FINAL DRAINAGE REPORT FOR SADDLEHORN RANCH – FILING 3

> February 4, 2022 Project No. 25142.05

El Paso County PCD File No.: SF-XX-XXX SF234 23-003

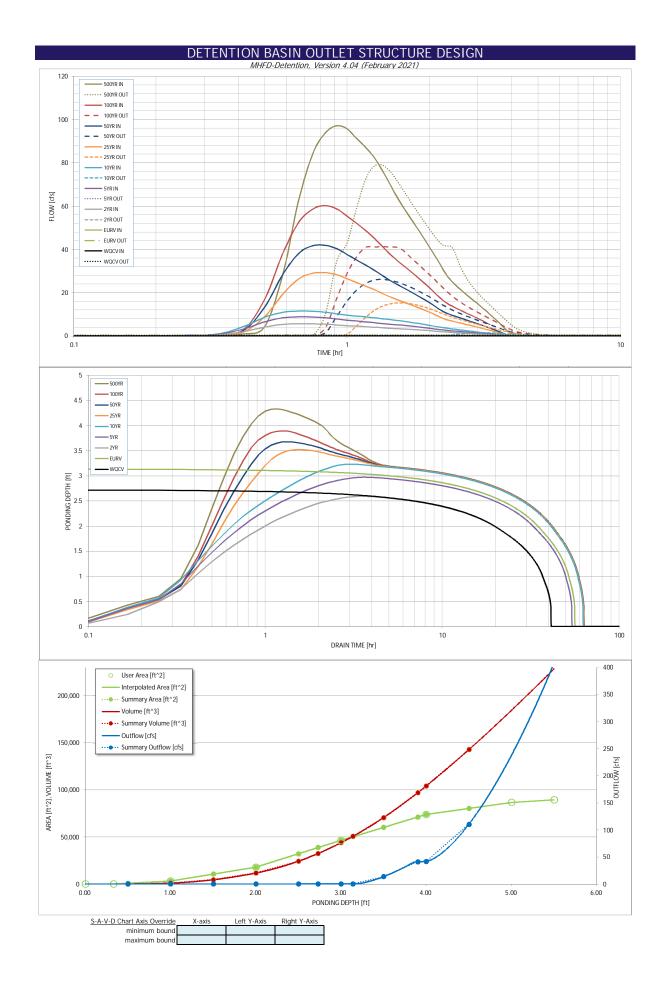
Fix drain time to be 40 hours

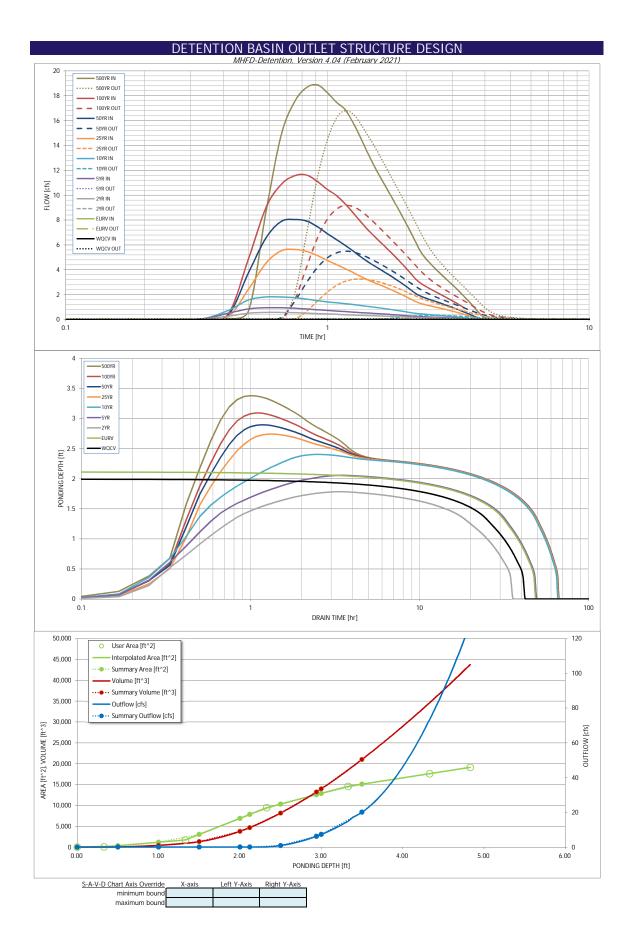
# Fix drain time to be 40 hours

# Pond E Spillway

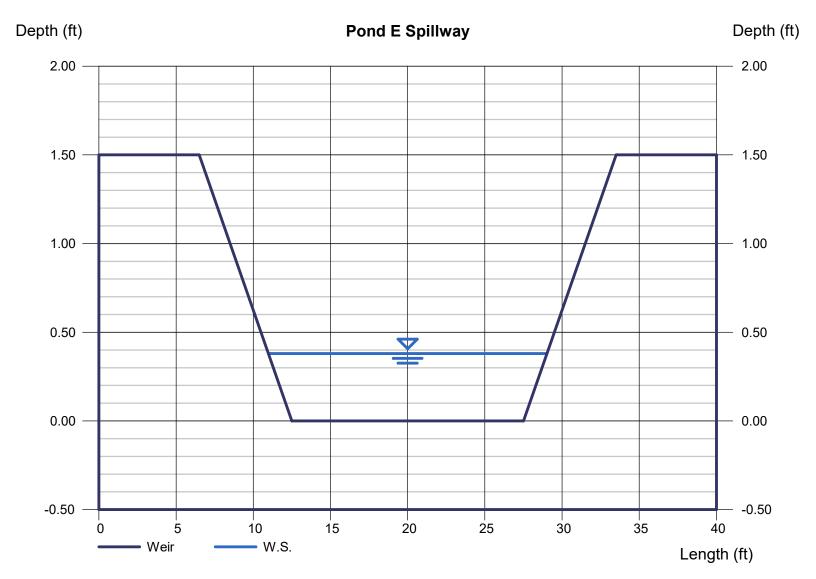
Update calculations if updates are made to the detention basin design spreadsheet
